BCA

ASSESSMENT REPORT

PROJECT:	10 London Street & 43 North Parade Campsie NSW 2194
STAGE:	Development Application Phase
REFERENCE:	24158.2-BCA
DATE:	17 April 2026
CLIENT:	ARADA Development Management Pty Ltd ('Arada')

Figure 5.1 – Exposure between different fire compartments on ground floor

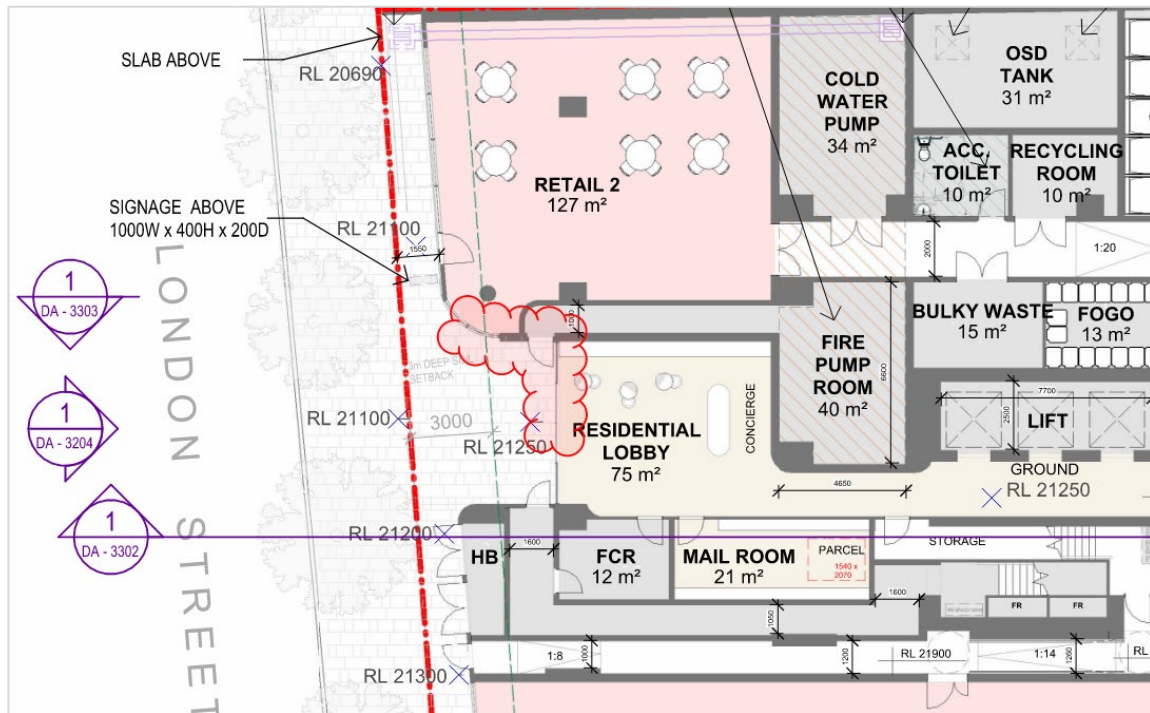
BCA Clause		Comment/s	Status
C4D3	Protection of openings in external walls	Openings in external walls required to achieve an FRL are identified as being located more than – (a) 3m from a side or rear boundary of the allotment; and (b) 6m from the far boundary of a road, river, lake or the like adjoining the allotment, if not located in a storey at or near ground level.	Note
C4D4	Separation of external walls and associated openings in different fire compartments	The distance between parts of external walls and any openings within them in different fire compartments separated by a fire wall must not be less than that set out in Table C4D4, unless— (a) those parts of each wall have an FRL not less than 60/60/60; and (b) any openings are protected in accordance with C4D5. In this regard, the following parts of external walls and openings within them between the <i>Class 2</i> and <i>Class 6</i> parts separated by a fire wall on the ground floor are identified as being located less than 4m apart, where configured at 90° apart.	CRA / PPS

Figure 5.2 – Level 1 exit travel distances

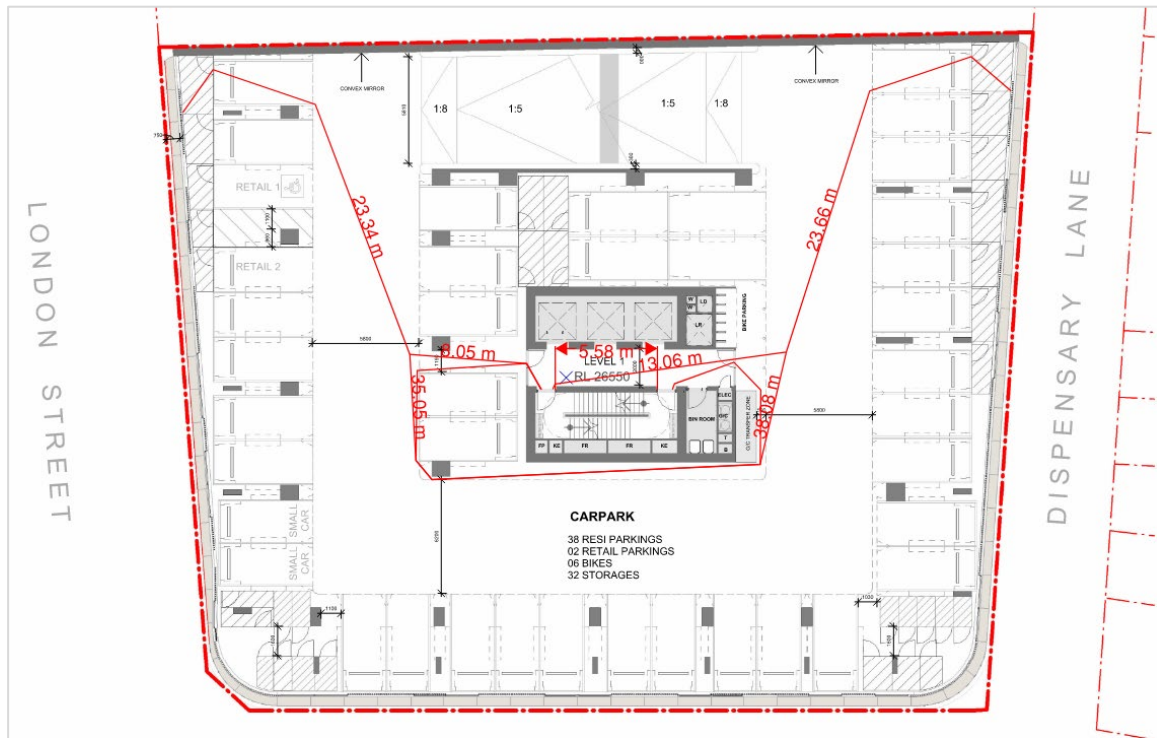
BCA Clause		Comment/s	Status
D2D3	Number of exits	The following egress provisions are identified as being provided - (a) Not less than 2 exits are provided from each storey; (b) The provision of a single exit is provided from parts on the ground floor storey, where direct egress to a road or open space is provided and satisfies D2D5 by the provision of a single exit.	C
D2D4	When fire isolated stairways and ramps are required	The required stairways serving the storeys above the ground floor have been assessed as fire isolated.	Note
D2D5	Exit travel distances	Extended exit travel distances are identified as occurring throughout the building, as follows – (a) Level 1 – Level 4 (i) The travel distance to a point of choice to alternative exits exceeds 20m, being up to ~24m. (b) Level 5 (i) The travel distance to a point of choice to alternative exits exceeds 20m, being up to ~25m. Notwithstanding the above, the exit travel distances are to be provided in accordance with the following – <i>Class 2 parts –</i> (a) The entrance doorway of any sole occupancy unit must be not more than – (i) 6m from an exit or from a point which travel in different directions to 2 exits is available; or (ii) 20m from a single exit serving the storey at the level of egress to a road or open space. (b) No point on the floor which is not a sole occupancy unit must be more than 20m from an exit or from a point at which travel in different directions to 2 exits is available. <i>Class 6 parts –</i> (a) No point on a floor must be more than 20 m from an exit, or a point from which travel in different directions to 2 exits is available, in which case the maximum distance to one of those exits must not exceed 40 m. (b) The distance to a single exit serving at the level of access to a road or open space may be increased to 30m. <i>Class 7 parts –</i> (a) No point on a floor must be more than 20 m from an exit, or a point from which travel in different directions to 2 exits is available, in which case the maximum distance to one of those exits must not exceed 40 m.	DNC / PPS

Figure 5.7 – Ground floor part plan

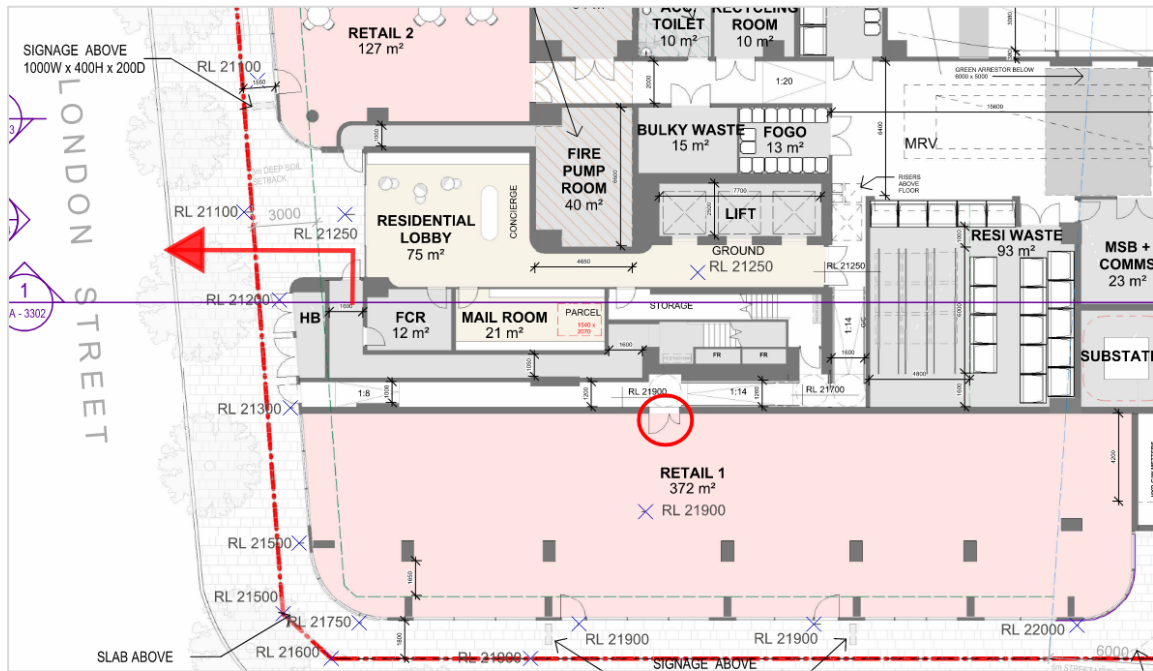
| | <p>(2) Each fire-isolated stairway or fire-isolated ramp must provide independent egress from each storey served and discharge directly, or by way of its own fire-isolated passageway –</p> <ul style="list-style-type: none"> (a) to a road or open space; or (b) to a point— <ul style="list-style-type: none"> (i) in a storey or space, within the confines of the building, that is used only for pedestrian movement, car parking or the like and is open for at least $\frac{2}{3}$ of its perimeter; and (ii) from which an unimpeded path of travel, not further than 20 m, is available to a road or open space; or (c) into a covered area that— <ul style="list-style-type: none"> (i) adjoins a road or open space; and (ii) is open for at least $\frac{1}{3}$ of its perimeter; and (iii) has an unobstructed clear height throughout, including the perimeter openings, of not less than 3 m; and (iv) provides an unimpeded path of travel from the point of discharge to the road or open space of not more than 6 m. <p>(3) Where a path of travel from the point of discharge of a fire-isolated exit necessitates passing within 6 m of any part of an external wall of the same building, measured horizontally at right angles to the path of travel, the following applies –</p> <ul style="list-style-type: none"> (a) That part of the wall must have— <ul style="list-style-type: none"> (i) an FRL of not less than 60/60/60; and (ii) any openings protected internally in accordance with C4D5; and (b) The protection required by (a) must extend for a distance of 3 m above or below, as appropriate, the level of the path of travel, or for the height of the wall, whichever is the lesser. <p>(4) If more than 2 access doorways, not from a sanitary compartment or the like, open to a required fire-isolated exit in the same storey—</p> <ul style="list-style-type: none"> (a) a smoke lobby in accordance with D3D7 must be provided; or (b) the exit must be pressurised in accordance with AS 1668.1-2015. | |

Figure 5.8 – Section showing enclosure of space below fire isolated stairway

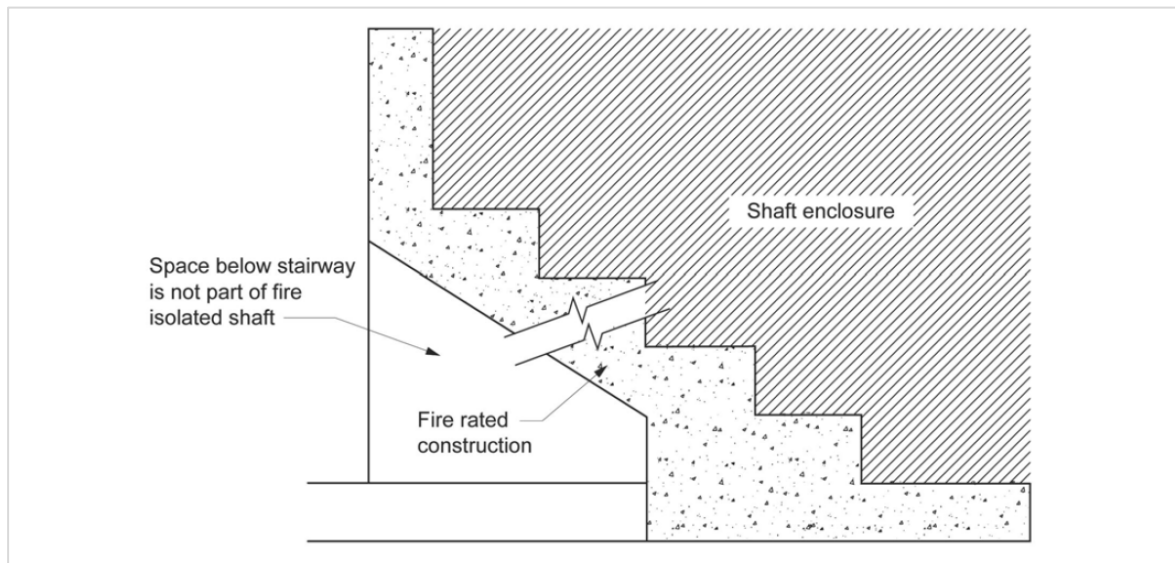
BCA Clause	Comment/s	Status
D3D9	Enclosure of space under stairs and ramps If the space below the required fire isolated stairway is within the fire isolated stairway shaft, it must not be enclosed to form a cupboard or similar enclosed space. <i>NOTE – If the stairway is fire isolated and the space below is not part of the fire isolated shaft, that space may be used as a cupboard, etc. This could be created by placing a fire rated slab under the flight of stairs.</i>	CRA

Figure 5.10 – Sliding door opening into fire isolated exit

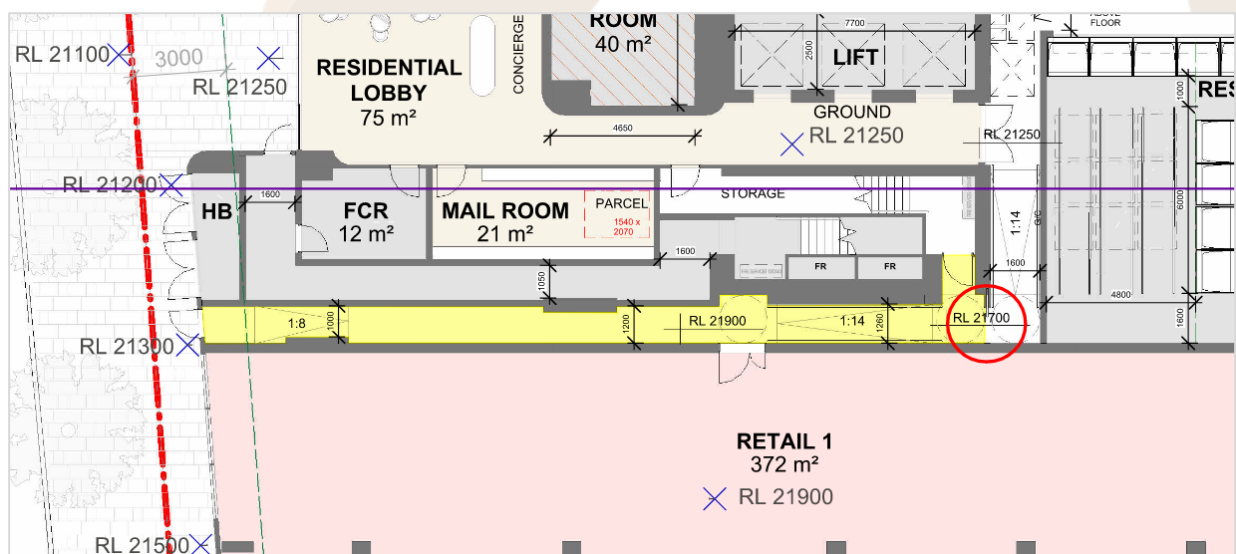
BCA Clause			Comment/s	Status
D3D24	Doorways and doors		The doorway opening into the fire isolated exit on the ground floor is identified as being fitted with a sliding door. Notwithstanding the above the following must be complied with - (1) A doorway serving as a required exit or forming part of a required exit — (a) must not be fitted with a revolving door; and (b) must not be fitted with a roller shutter or tilt-up door unless - (i) it serves a <i>Class 6</i> or <i>7</i> building part with a floor area not more than 200 m²; and (ii) the doorway is the only required exit from the building or part; and (iii) it is held in the open position while the building or part is lawfully occupied; and (c) must not be fitted with a sliding door unless - (i) it leads directly to a road or open space; and (ii) the door is able to be opened manually under a force of not more than 110 N; and (d) if fitted with a door which is power-operated - (i) it must be able to be opened manually under a force of not more than 110 N if there is a malfunction or failure of the power source; and (ii) if it leads directly to a road or open space it must open automatically if there is a power failure to the door or on the activation of a fire or smoke alarm anywhere in the fire compartment served by the door. (2) A power-operated door in a path of travel to a required exit, must be able to be opened manually under a force of not more than 110 N if there is a malfunction or failure of the power source.	DNC

Figure 5.11 – Direction of swing to doors serving Retail 1

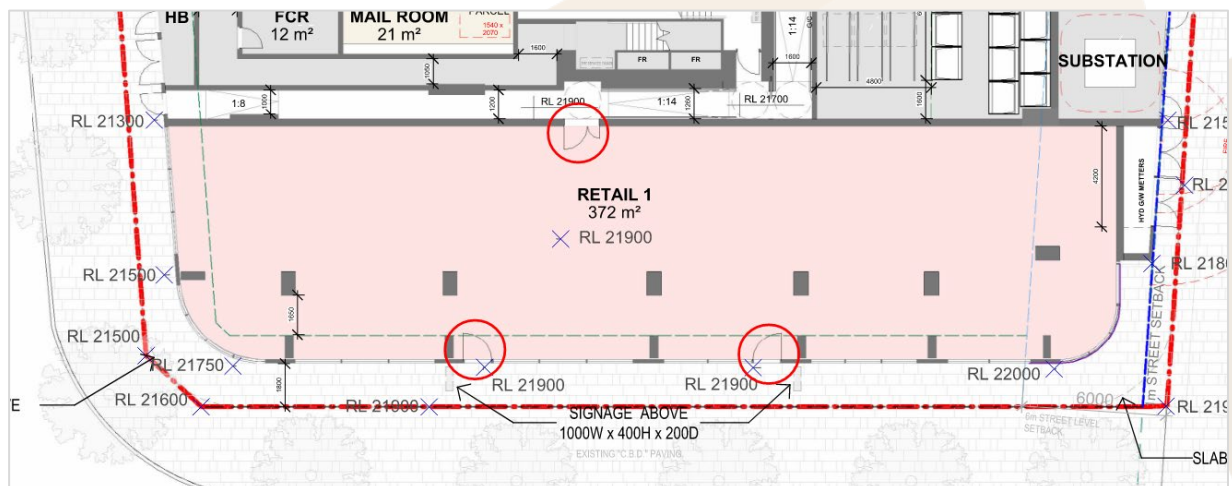
D3D25	BCA Clause	Comment/s	Status
	Swinging doors	The swing doors serving as required exits from the Retail 1 tenancy are identified as swinging against the direction of egress. Notwithstanding the above, swinging doors in a required exit or forming part of a required exit must be provided in accordance with the following - (a) must not encroach— (i) at any part of its swing by more than 500 mm on the required width (including any landings) of a required stairway, ramp or passageway if it is likely to impede the path of travel of the people already using the exit. (ii) when fully open, by more than 100 mm on the required width of the required exit; and (b) must swing in the direction of egress unless - (i) it serves a building or part with a floor area not more than 200 m², it is the only required exit from the building or part and it is fitted with a device for holding it in the open position; or (ii) it serves a sanitary compartment or airlock (in which case it may swing in either direction); and (c) must not otherwise impede the path or direction of egress.	DNC / PPS
